Project: IEEE P802.15 Working Group for Wireless Personal Area Networks (WPANs)

Submission Title: [Resolution for the initial SB comment No.3]

Re: [Response to the initial SB for the IEEE 802.15.7 standard]

Resolution for the initial SB comment No.3

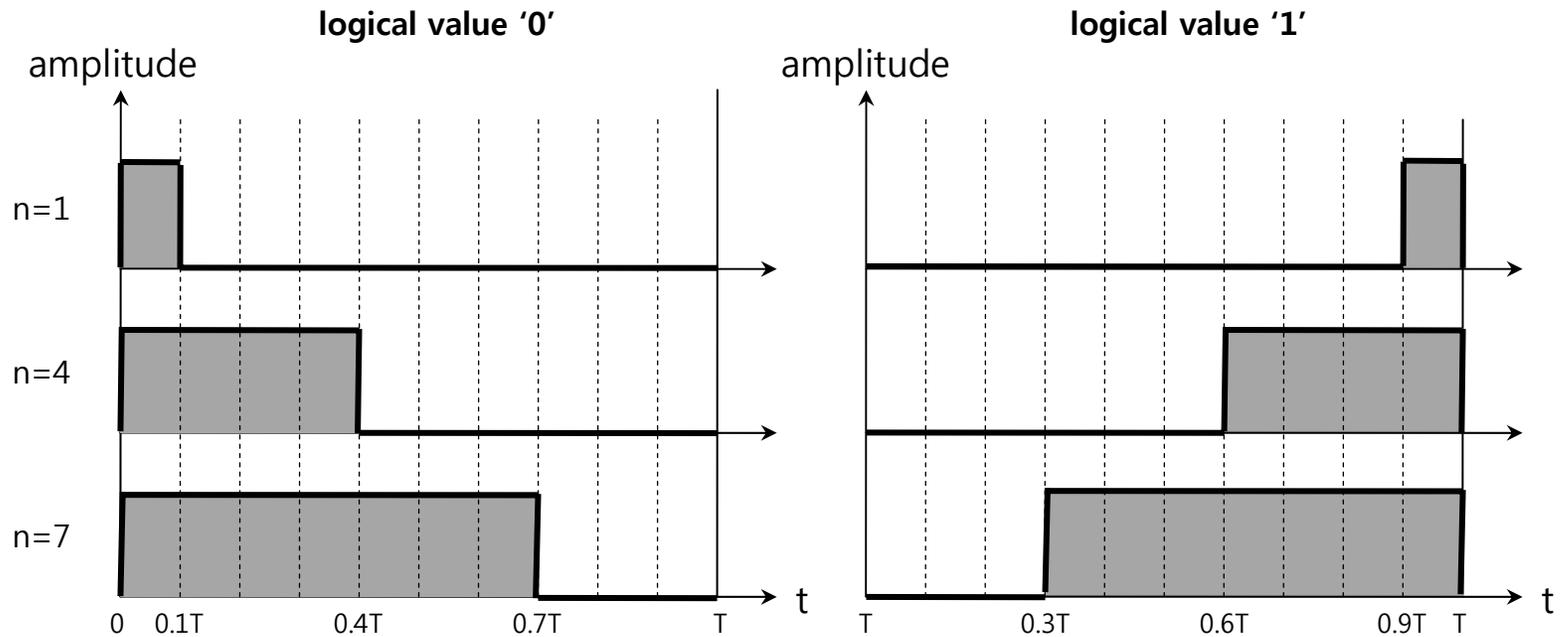
Comment No.	Name	Page	Subclause	Line	Comment	Proposed Change
3 (line 54)	Rajagopal, Sridhar	16	4.4.3.2.1	10	4.4.3.2.1 refers to 8.5.3 which refers to 4.4.3.2	fix circular reference

- 4.4.3.2.1 Intra-frame flicker mitigation
 - Intra-frame flicker mitigation is accomplished by either the use of run length limiting coding, modulation scheme, or both. Specifically, these schemes are manchester encoding as specified in 10.5.2, 4B6B encoding as specified in 10.5.1, 8B10B encoding as specified in 11.3 or **VPPM as specified in 8.5.3.**
- Main issue
 - 8.5.3 does not specify the VPPM definition, either.
 - **No place for the VPPM specification in D4.**

Logical value	Physical value	
0	High (LED on)	$0 \leq t < 0.1 \times nT$
	Low (LED off)	$0.1 \times nT \leq t < T$
1	Low (LED off)	$0 \leq t < (1 - 0.1 \times n)T$
	High (LED on)	$(1 - 0.1 \times n)T \leq t < T$

n is the required VPPM dimming level and integer ($0 < n < 10$)

- The data mapping for VPPM mode in **PHY I** is shown in Table xx and Figure xx. The data mapping for VPPM shall be defined as Table xx. The physical value mapped from the logical data “0” has a transition from ‘high’ to ‘low’ and the physical value mapped from the logical data “1” has a transition from ‘low’ to ‘high’ as shown in Table xx and Figure xx. ‘n’ in Table xx is the dimming level required only by VPPM and a integer **within the range of 1 to 9 (or 0 to 10, I’m not sure)** so that VPPM modulated signals can support 10% dimming resolution only by VPPM. Figure xx shows the examples of the VPPM modulated waveform when the dimming levels, n, are 1, 4, and 7, respectively.
- Table caption : Table xx – Definition of data mapping for VPPM mode in **PHY I**
- Figure caption : Figure xx - Examples of the VPPM modulated waveforms in **PHY I** representing logical data ‘0’ and ‘1’

- The data mapping for VPPM mode in **PHY II** is shown in Table yy and Figure yy. The data mapping for VPPM shall be defined as Table yy. The physical value mapped from the logical data “0” has a transition from ‘high’ to ‘low’ and the physical value mapped from the logical data “1” has a transition from ‘low’ to ‘high’ as shown in Table yy and Figure yy. ‘n’ in Table yy is the dimming level required only by VPPM and a integer **within the range of 1 to 9 (or 0 to 10, I’m not sure)** so that VPPM modulated signals can support 10% dimming resolution only by VPPM. Figure yy shows the examples of the VPPM modulated waveform when the dimming levels, n, are 1, 4, and 7, respectively.
- Table caption : Table yy – Definition of data mapping for VPPM mode in **PHY II**
- Figure caption : Figure yy - Examples of the VPPM modulated waveforms **in PHY II** representing logical data ‘0’ and ‘1’
